Access Compliance Report Public Rights-of-Way (Curb Ramps)

Main Street: SECOND_ST Cross Street: SECOND_ST Location: S

ADA ID: RPRK211029124309 Ramp Type: Type 4 - Parallel Initial Pass/Fail: Fail Overall Compliance: No Severity Score: 2

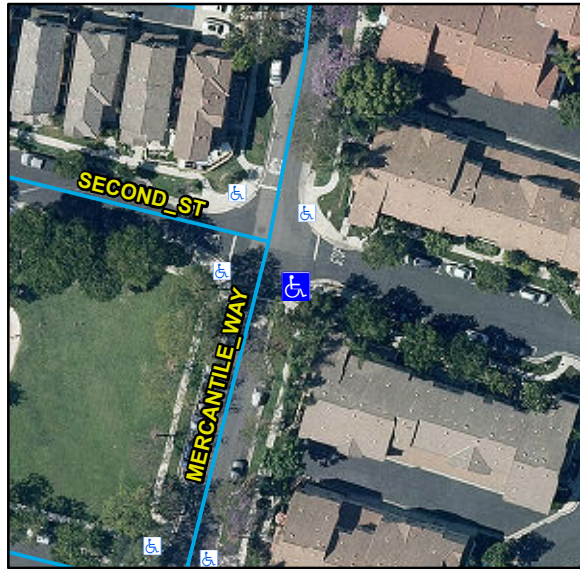
Surveyor Notes:

N/A

Possible Solutions:

Remove & Replace Curb Ramp With Two New Directional Ramps or Equivalent.

OC Std/PROW:

R204.3, R304.5.3, STD 1115
